H. B. ROBINSON STEAM ELECTRIC PLANT, UNIT NO. 2  
DOCKET NO. 50-261/LICENSE NO. DPR-23

RESPONSE TO NRC REQUEST FOR ADDITIONAL INFORMATION  
REGARDING REVIEW OF REFUELING OUTAGE 25 INSPECTIONS  
OF THE REACTOR VESSEL NOZZLE DISSIMILAR METAL BUTT WELDS

**RESPONSE TO NRC REQUEST FOR ADDITIONAL INFORMATION  
REGARDING REVIEW OF REFUELING OUTAGE 25 INSPECTIONS  
OF THE REACTOR VESSEL NOZZLE DISSIMILAR METAL BUTT WELDS**

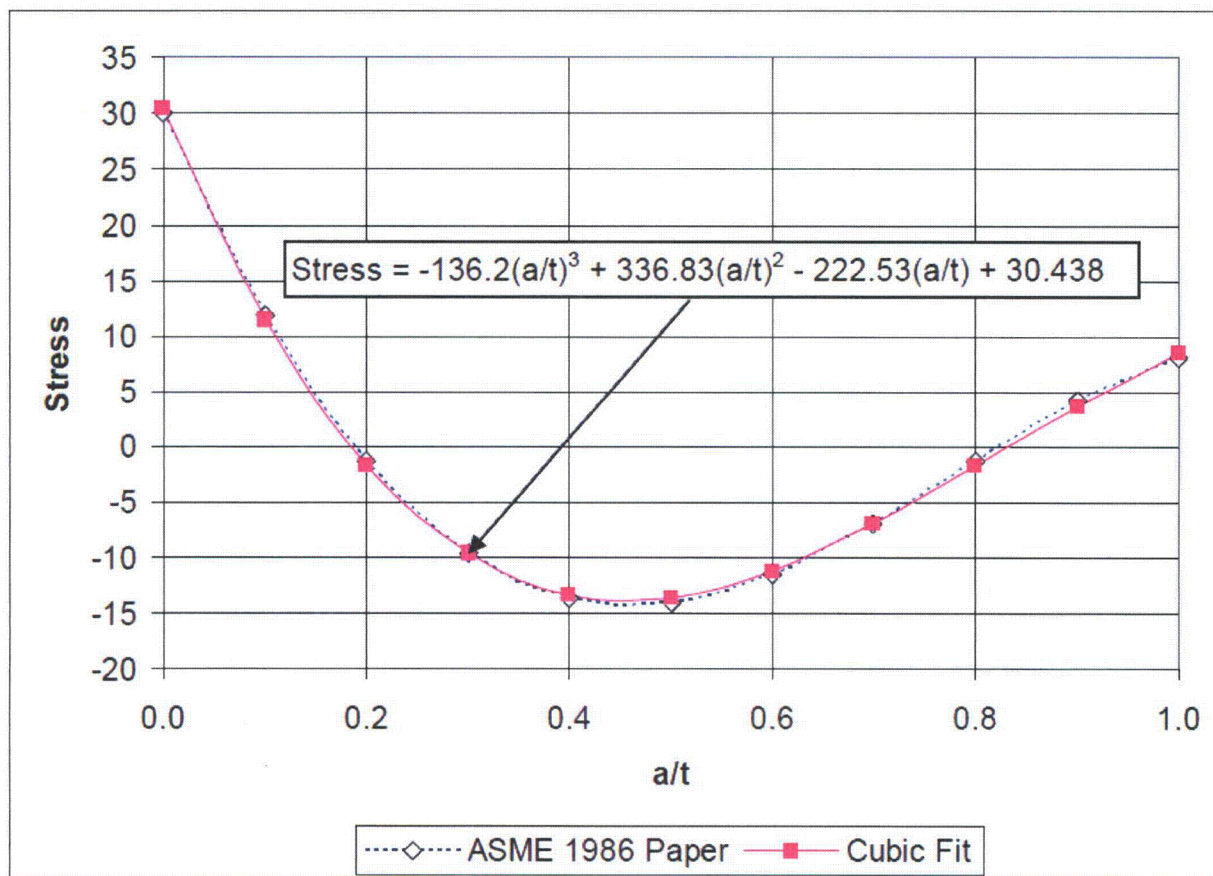
Page 2-3. A third order approximation is used for the through wall thickness stress profile. In many cases, this representation may not be adequate, especially for welding residual stress. This approximation can underpredict the stresses on the crack face and provide non-conservative approximations of time to leakage. Discuss the validity of using the third order approximation for the through wall thickness stress.

The through-wall residual stress profiles used in the evaluation are shown in Figure 3-5 on page 3-12 of WCAP-15620-P. This residual stress profile was obtained from the "Journal of Pressure Vessel Technology," Pressure Vessel and Pipe Codes, Volume 108, August 1986, "Evaluation of Flaws in Austenitic Steel Piping." A third order approximation is adequate to represent such through-wall residual stress profile as shown below even though the actual axial residual stress distribution is a fourth order polynomial.

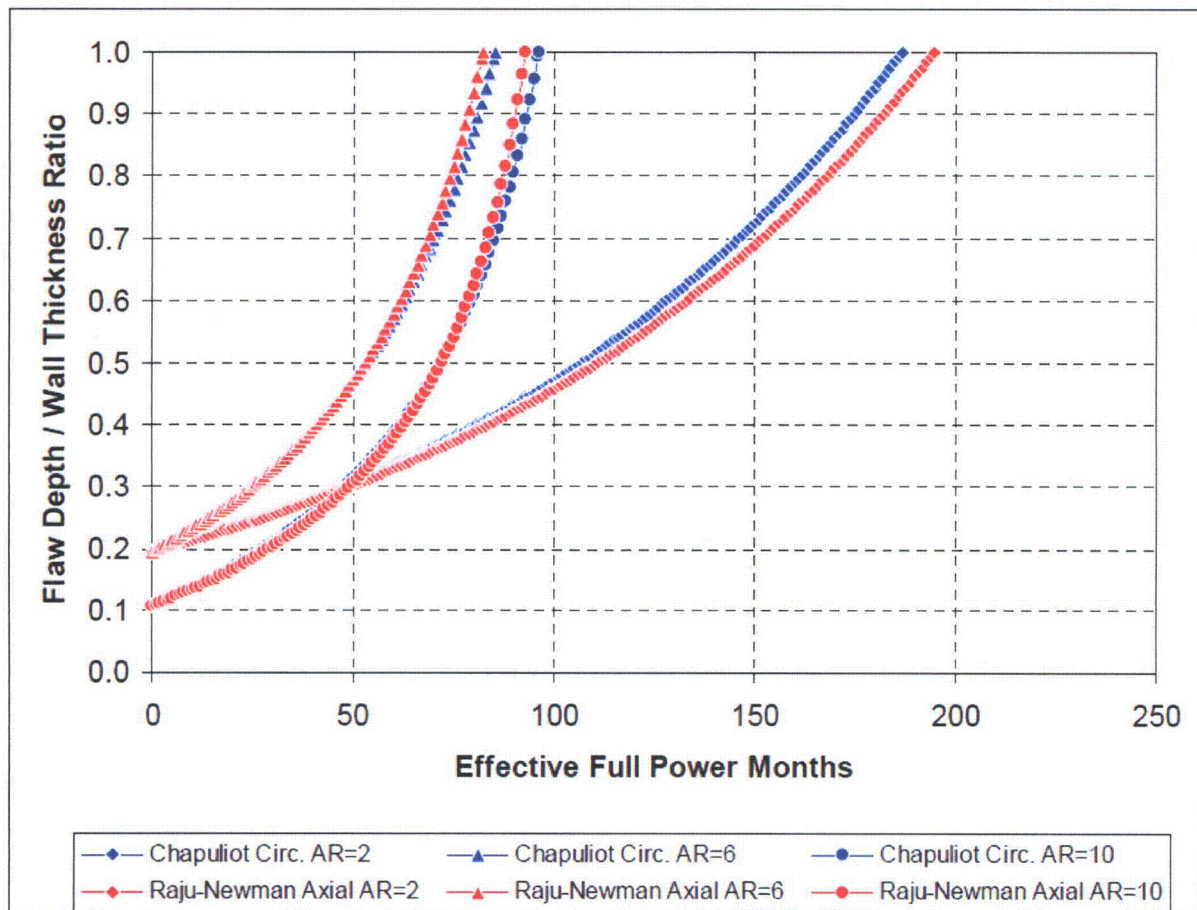
Page 2-3. The licensee stated that the same influence functions for stress intensity are used for longitudinal and circumferential flaws because there is no difference until the crack is deep. Both American Petroleum Institute (API) and American Society of Mechanical Engineers (ASME) Boiler and Pressure Vessel Code, Section XI, have published influence functions that are different for circumferential and longitudinal cracks and illustrate they are a function of  $R/t$ , location (internal/external), etc. Please provide references or examples to show why the same influence functions for stress intensity can be used for longitudinal and circumferential flaws.

Figures 197 and 199 in "Compendium of Stress Intensity Factors, D. P. Rooke and D. J. Cartwright, London, Her Majesty's Stationery Office," provides the crack tip stress intensity factors respectively for a longitudinal and circumferential flaw in a cylindrical shell. A comparison of the magnification factors for the same uniform membrane stress field indicated that the stress intensity factor calculated based on a longitudinal flaw would be conservative for a circumferential flaw.

Primary Water Stress Corrosion Crack (PWSCC) growth curves with various aspect ratios (flaw length/flaw depth ratio) were generated using the stress intensity factor expression for

circumferential flaw (S. Chapuliot, M. H. Lacire, and P. Le. Delliou, "Stress intensity factors for internal circumferential cracks in tubes over a wide range of radius over thickness ratios," ASME PVP Vol. 365, 1998) and the Raju-Newman stress intensity factor expression for longitudinal flaw (Raju, I. S., and Newman, J. C., "Stress Intensity Factors for Internal and External Surface Cracks in Cylindrical Vessels," Journal of Pressure Vessel Technology, Vol. 104, 1982, pp. 293-298). The input to the PWSCC growth analysis is the same as those used in WCAP-15620-P for circumferential flaws at the outlet nozzle dissimilar metal weld. The crack growth results shown below indicated that the results are in good agreement with only minor differences.
